**AGENDA**  
**PLANNING & ZONING COMMISSION SPECIAL MEETING**  
**TUESDAY, JULY 26, 2022 - 3:30 PM**  
**McAllen Development Center, 311 N. 15<sup>th</sup> Street, McAllen, Texas**  
**EXECUTIVE CONFERENCE ROOM, PLANNING DEPARTMENT**

**Memo**

**TO:** Planning and Zoning Commission  
**FROM:** Planning Staff  
**DATE:** July 11, 2022  
**SUBJECT:** **SITE PLAN APPROVAL FOR LOT 10, CITRUS GROVE PLAZA PHASE 1-A, LOT 10. 4129 EXPRESSWAY 83. (SPR2022-0036)**

**A-2**  
SITE PLAN

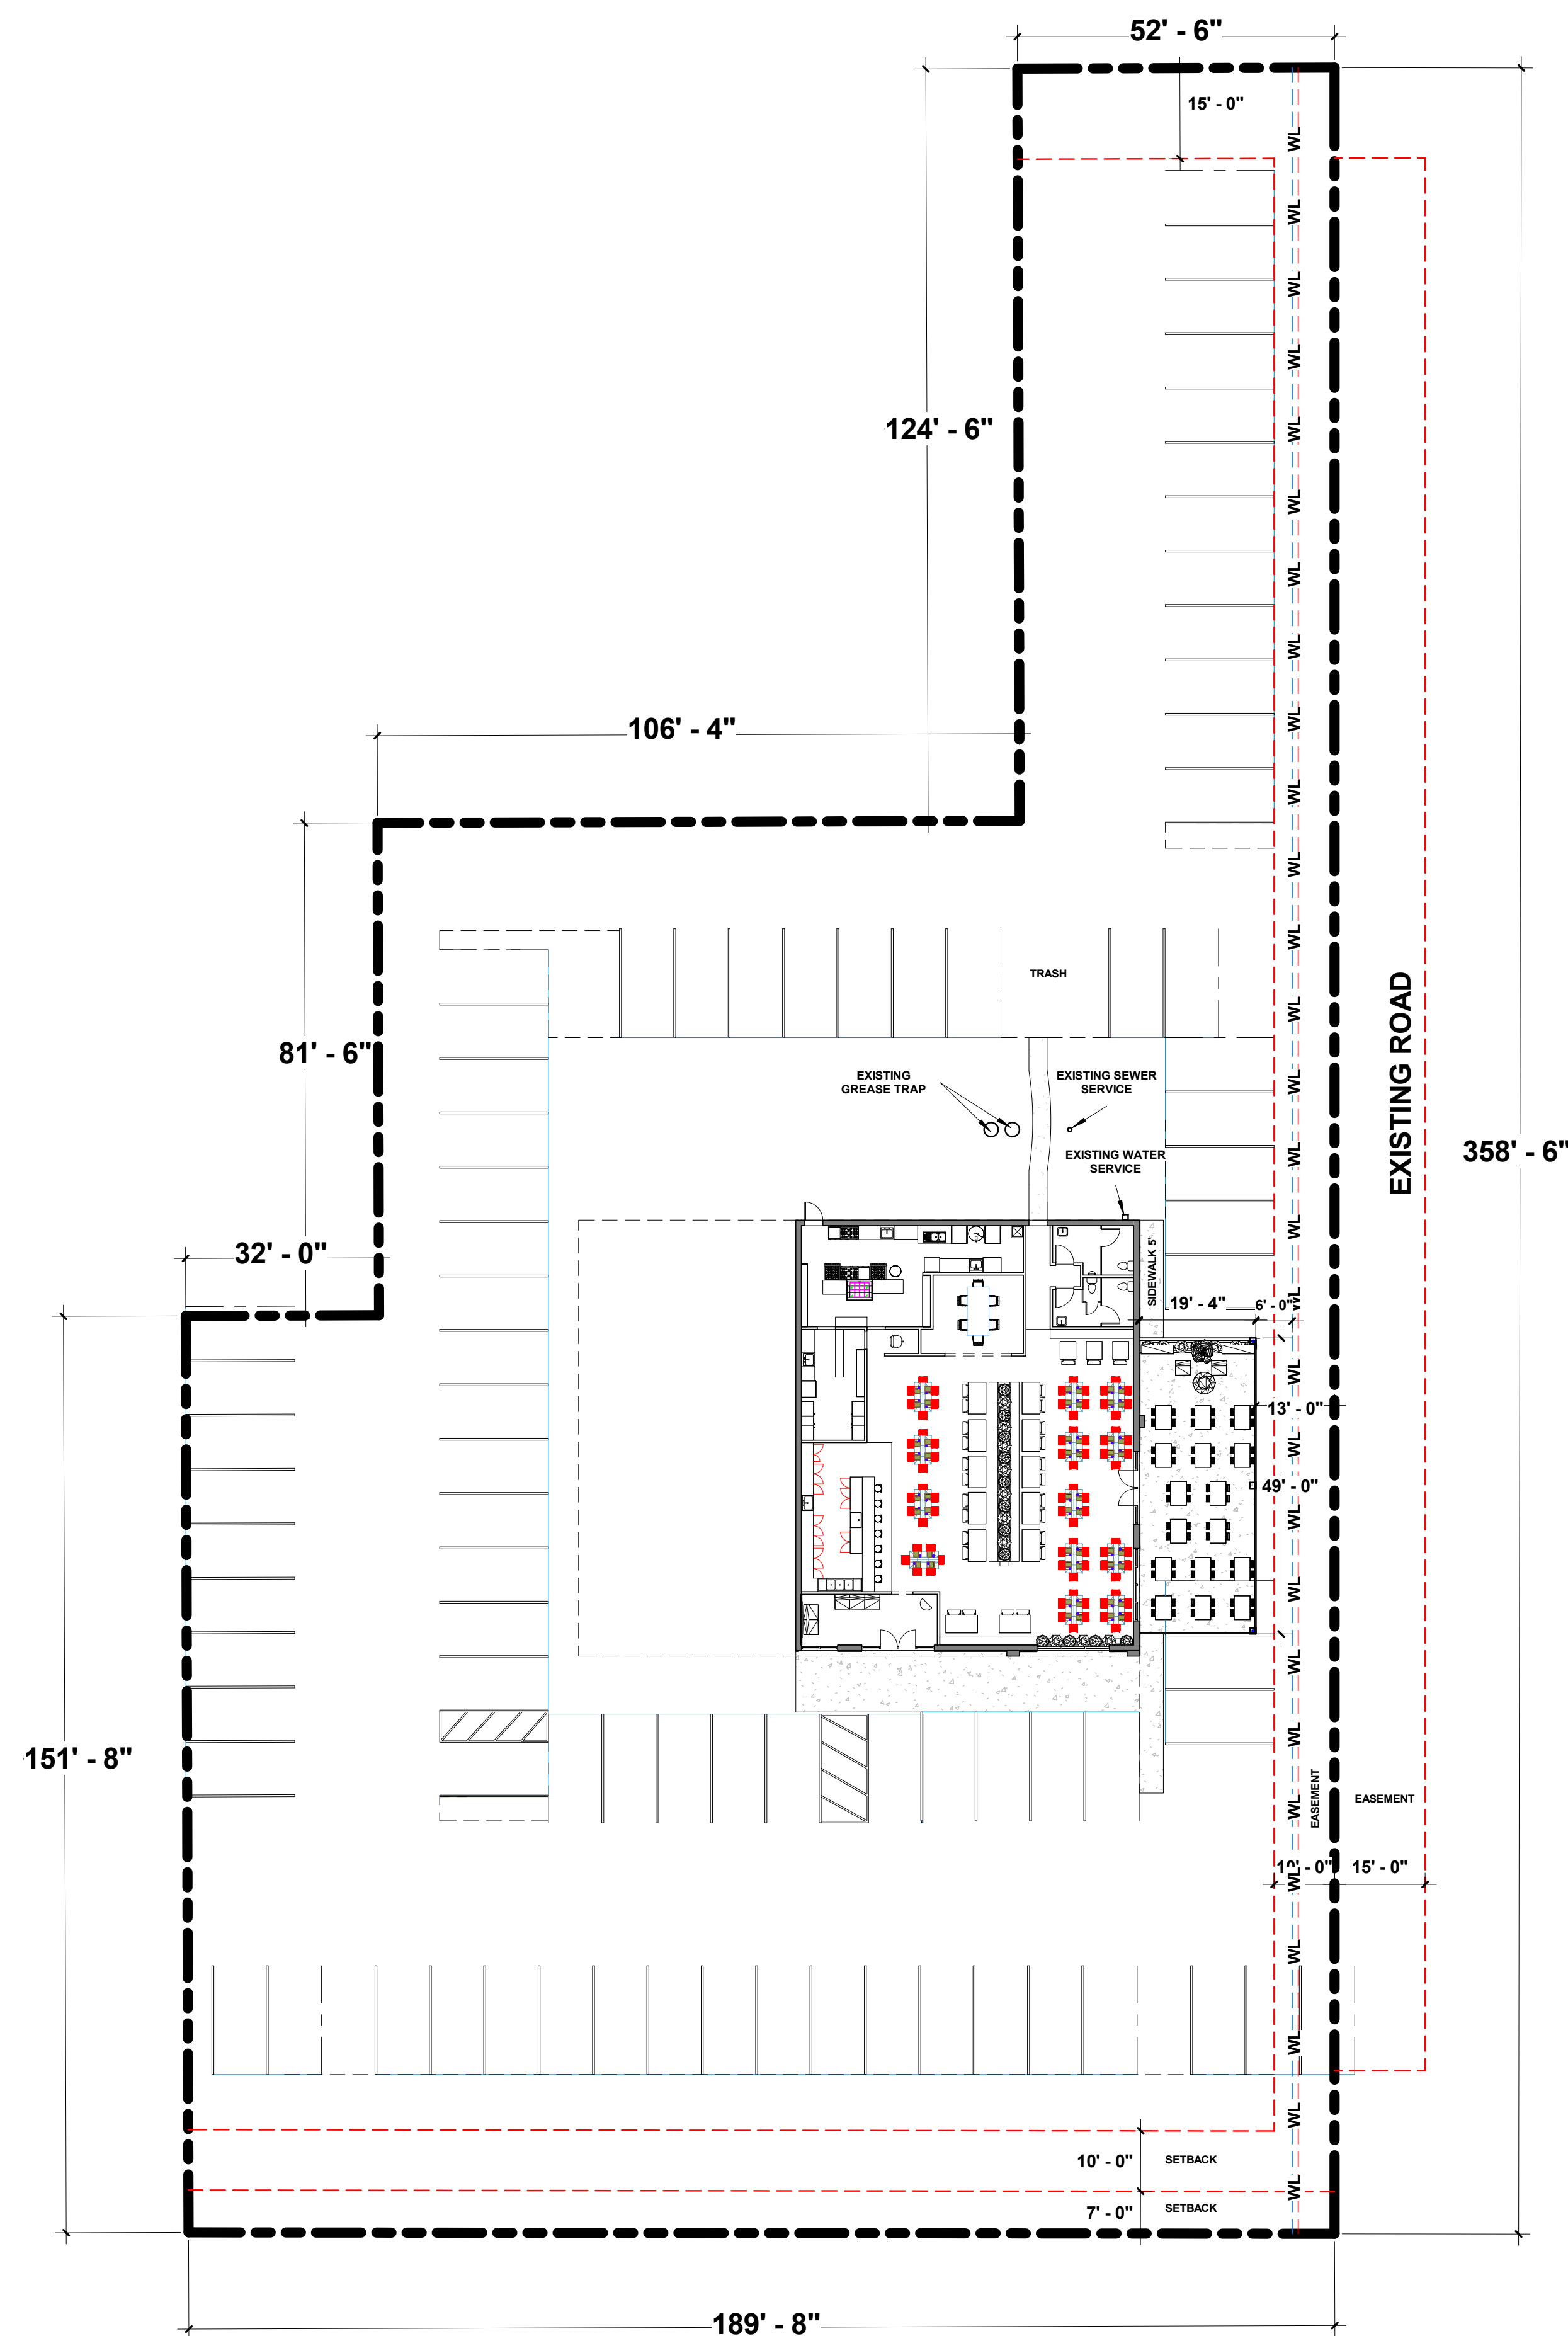
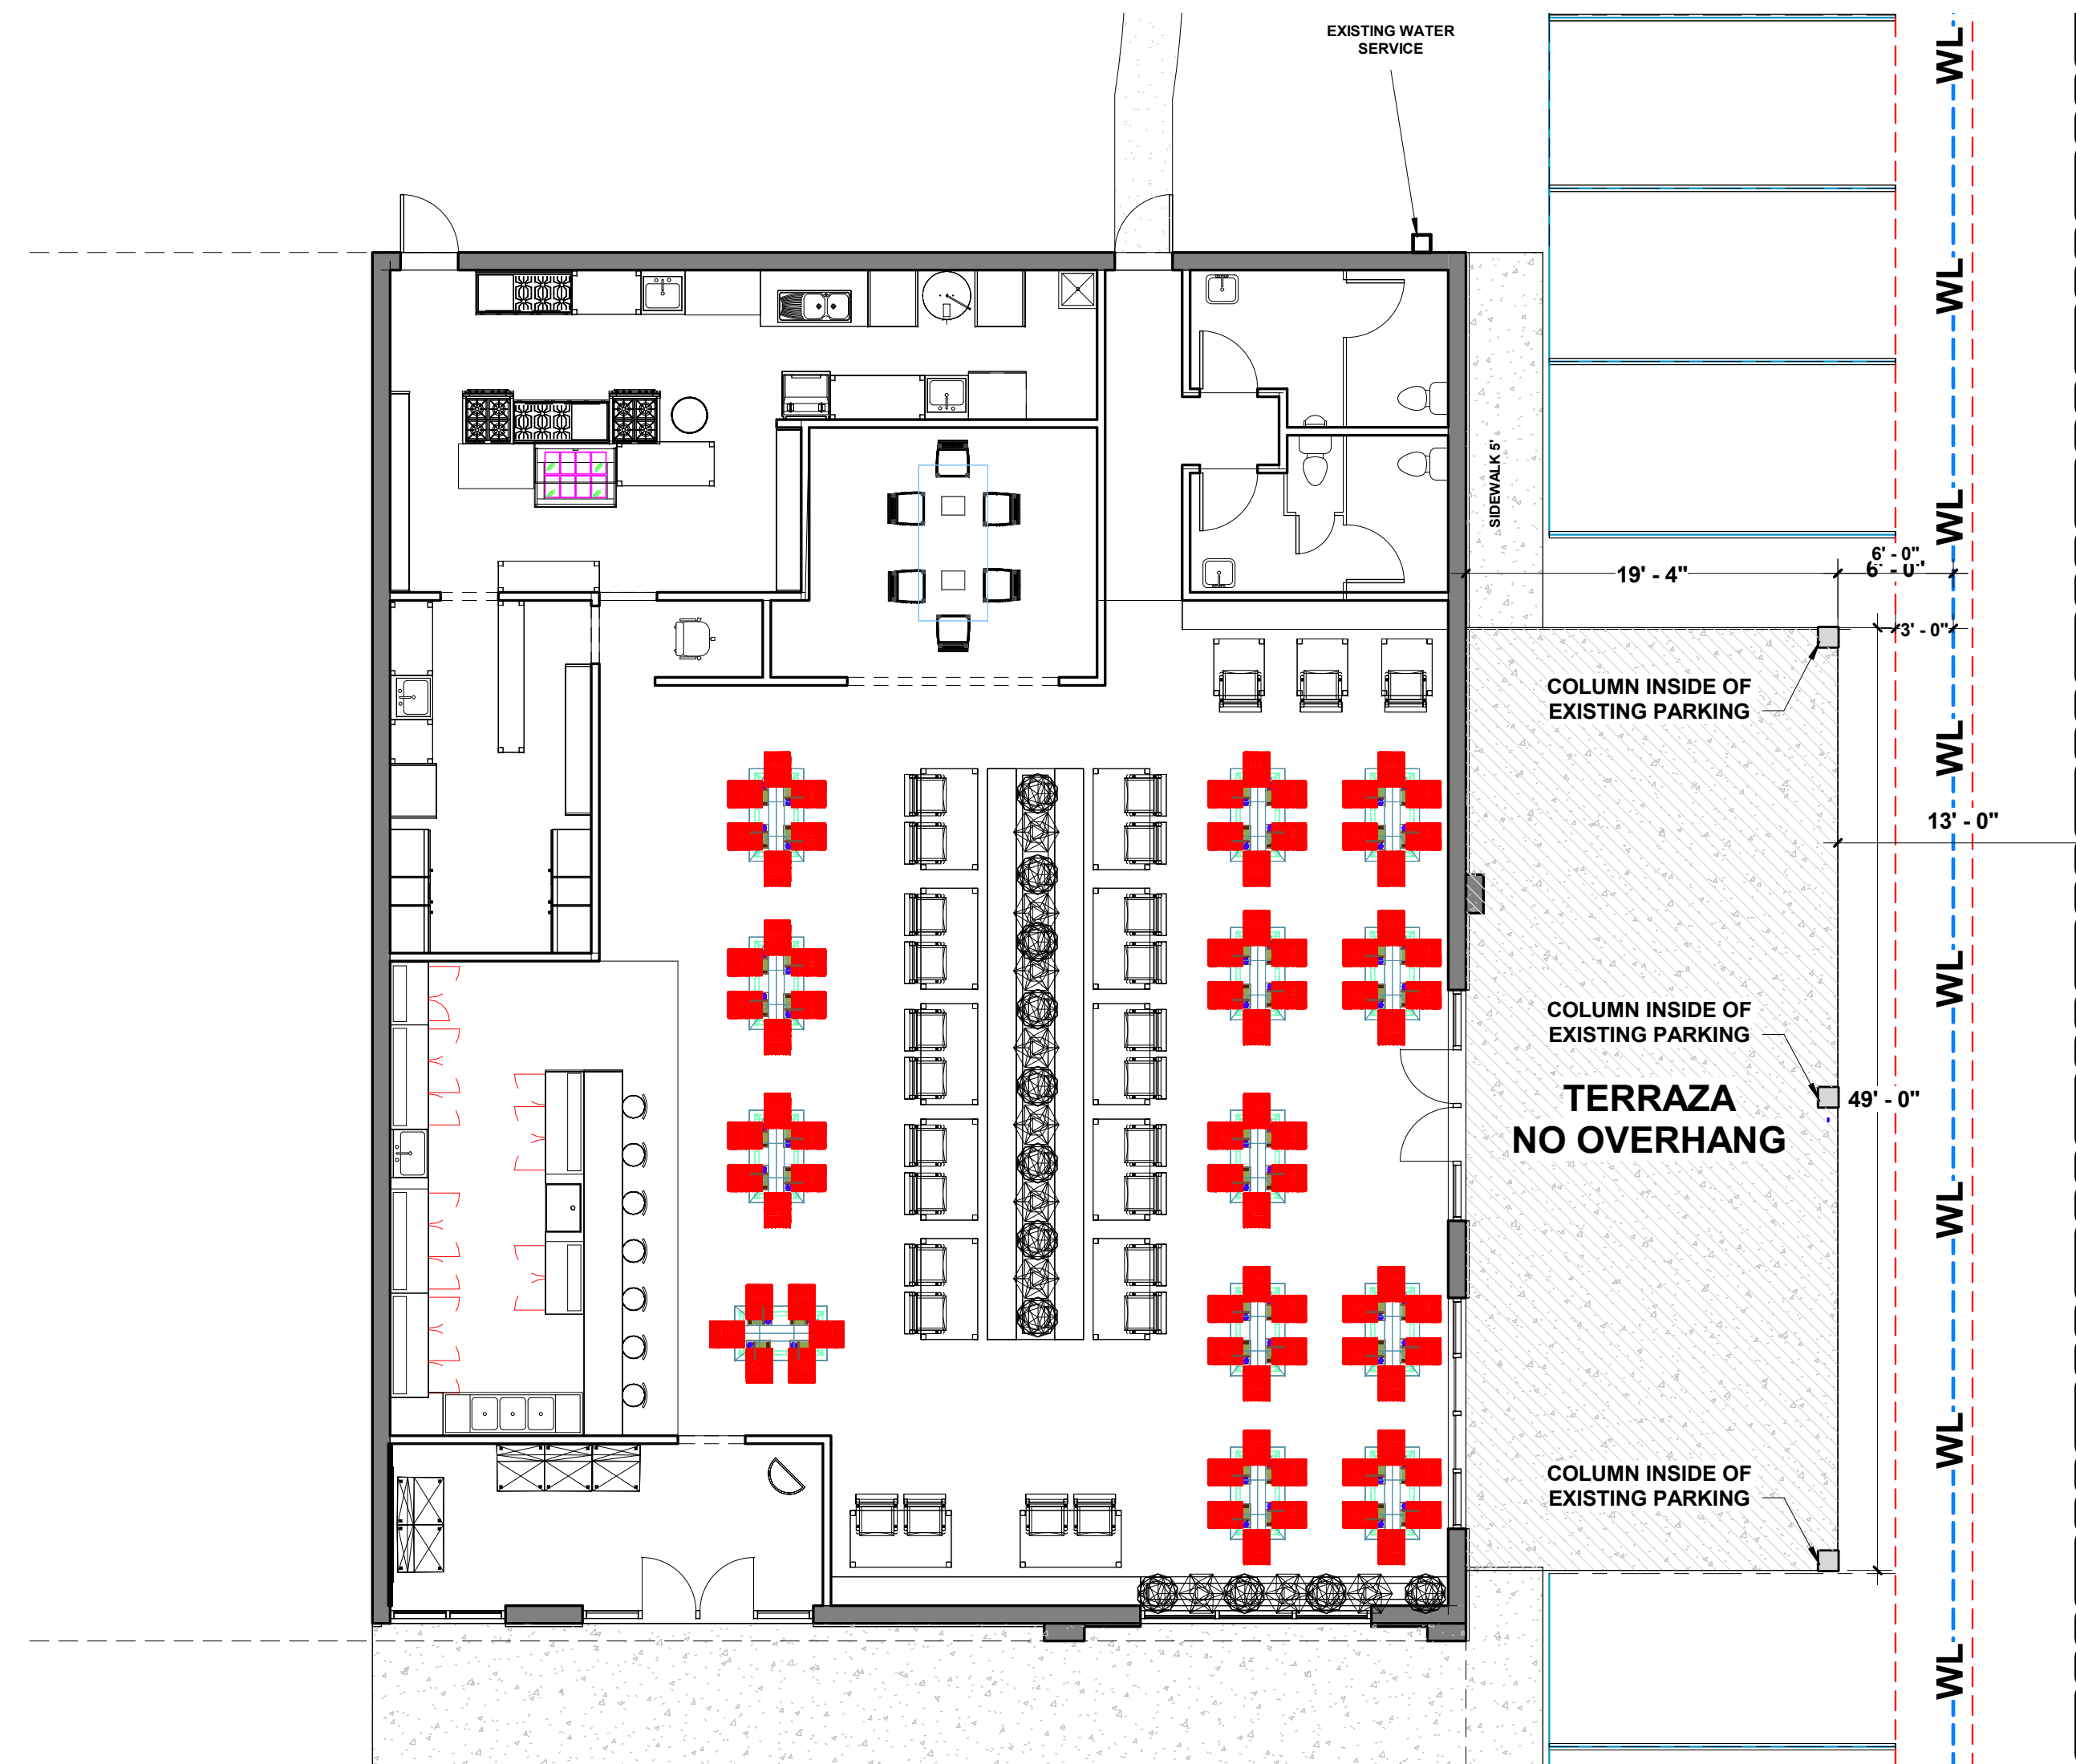
**ANALYSIS:** Based on the square footage of the proposed addition of patio area, 75 parking spaces are required, 85 parking spaces are provided on site. The accessible spaces must maintain existing to the original site plan approval. Access to the site is along the Frontage Road and Colbath Road. Required landscaping for the lot is 4,809 sq. ft., 8,608 sq. ft. is provided, with trees required as follows: 16 – 2 1/2” caliper trees, or 8 – 4” caliper trees, or 4 – 6” caliper trees, or 32 palm trees. Applicant must maintain existing landscaping. Any dead grass, trees, or plants must be replaced as well as any non-working irrigation system. Minimum 10' wide landscape strip (5' wide with 3' hedge for properties less than 200' deep) required inside the property line along Expressway 83, Colbath Road, and Bentsen Road. Fifty percent of the landscaping must be visible in front areas, and each parking space must be within 100 ft.

As per Utilities Engineering Dept., the applicant will need to provide a revised utility layout showing:

Staff recommends approval of the site plan subject to the conditions noted, paving and Building Permit requirements, Utilities Engineering Dept. requirements, and the subdivision and zoning ordinances.
